## Nuclear Information and Resource Service

October 16, 1995

### RE: Safety Evaluation of the Core Shroud Fix at Oyster Creek Nuclear Generating Station

FIGURE 4

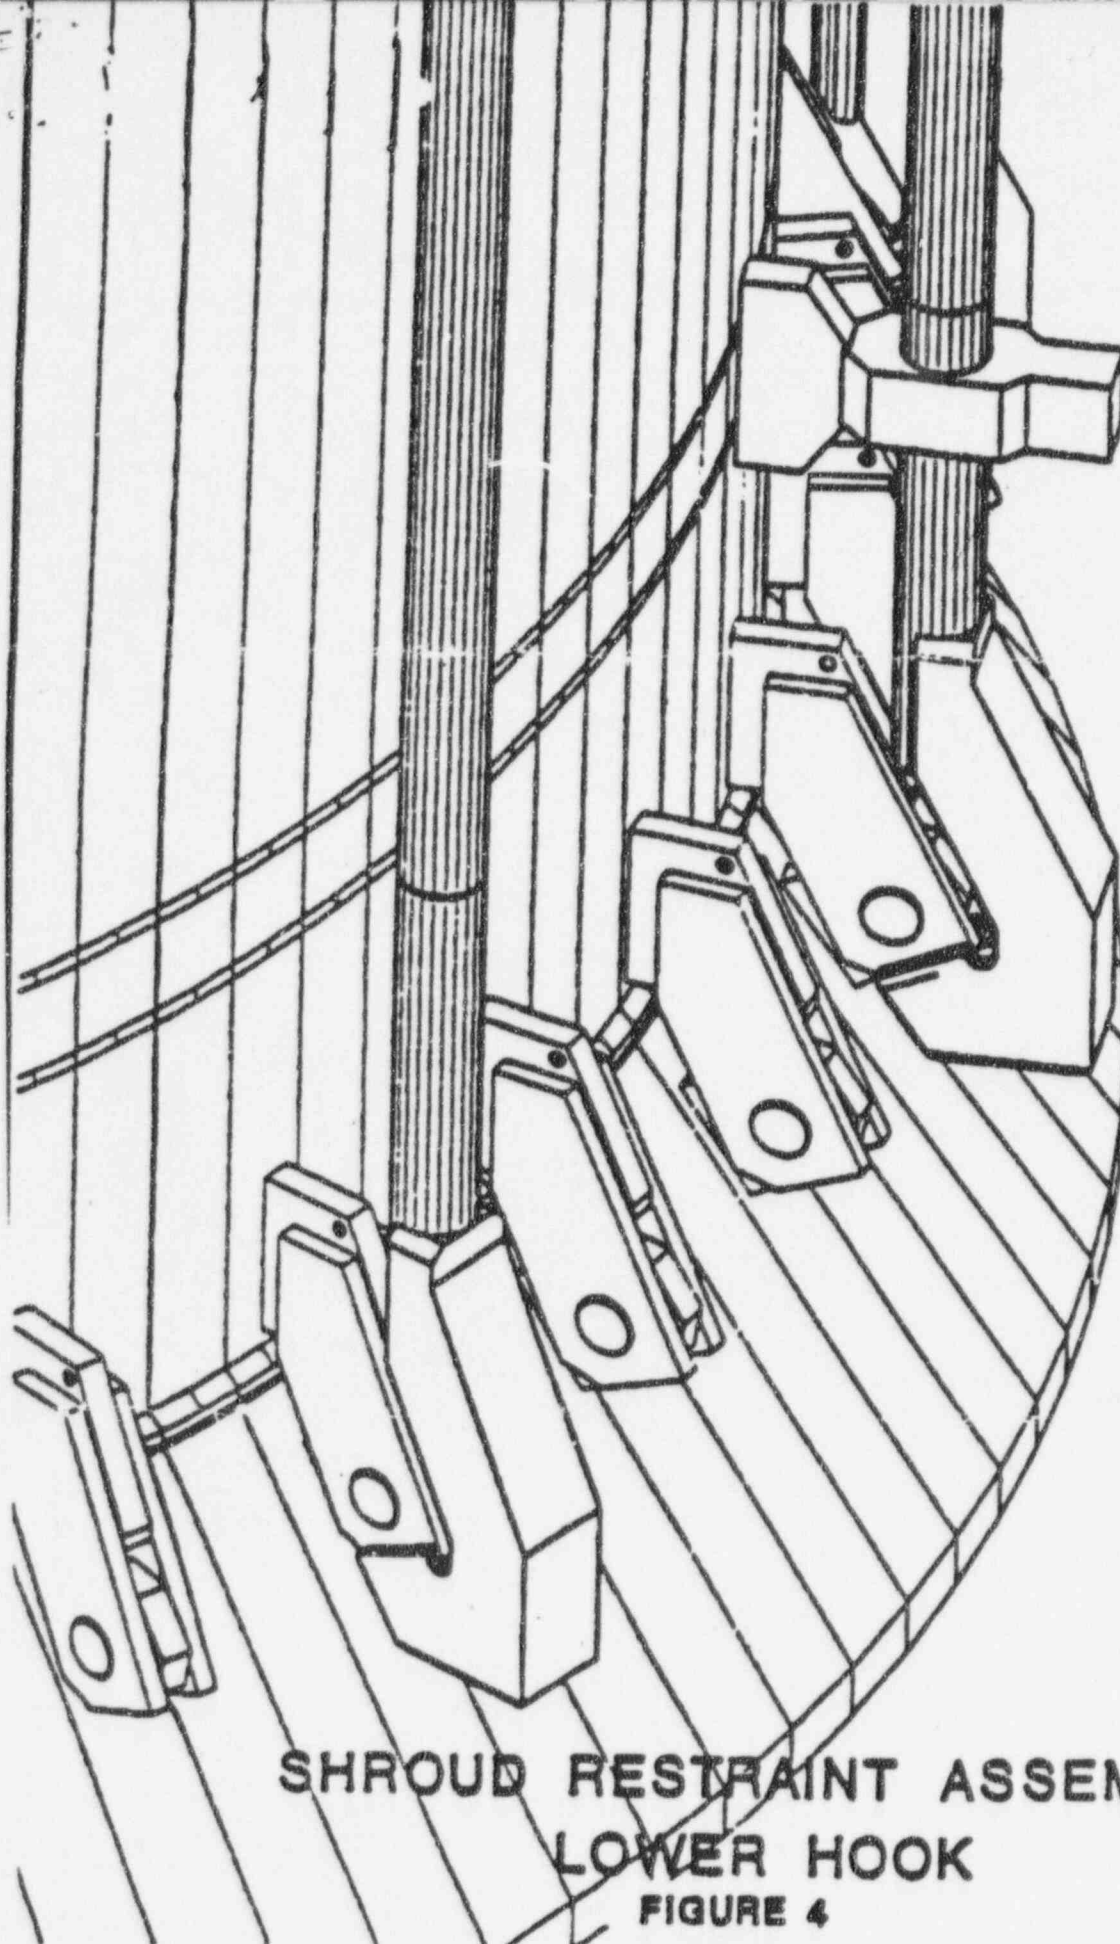
Specifically, NIRS concerns with the Oyster Creek's Core Shroud Repair focus on the Shroud Restraint Assembly Lower Hook depicted in Figure 4 of the NRC Safety Evaluation dated November 25, 1994. [Attached]

NIRS contends that the lower hooks for the restraint assemblies are dependent on the originally installed gussets, which in turn are composed of plates of Type 304 stainless steel and Inconel 600. NIRS contends that the anchor system utilized for the core shroud fix is dependent upon a susceptible material which has been subject to long-term exposure by the same harsh operational environment that incubated cracking of the core shroud. These conditions are identified in NUREG/CR-5754 "Boiling Water Reactor Internals Aging Degradation Study."

NIRS contends that both the NRC and the licensee ignored information contained within NUREG/CR-5754 which warns that it is "essential to control or eliminate stressors" (emphasis added). To the contrary, GPUN incorporated "a susceptible material" in the fabrication of the anchor system for the core shroud fix, namely, Type 304 stainless steel and Inconel 600 which have been subjected to aging conditions for 25 years during the reactor's operation.

- 1) Has the NRC staff evaluated or reviewed the licensee's evaluation of the effects of stress corrosion cracking (SCC), fatigue, erosion, embrittlement, and creep on the plate material and its Heat Affected Zones (HAZ) which fabricates the gussets? Is that documentation available for public review?

- 2) Given that a susceptible material has already been incorporated into the Shroud Restraint Assemblies, what has the licensee done to mitigate the other two conditions necessary to incubate SCC as described in NUREG/CR-5754?

- 3) Where has NRC or the licensee evaluated the consequences of the failure of one or more Type 304 stainless steel gussets used to anchor the Shroud Restraint Assemblies?

- 4) Does the NRC plan to require frequent enhanced inspections of the tie rod anchor plates in question? If so, what does the NRC consider to constitute frequent and enhanced inspections for age-related deterioration? If not, why not?
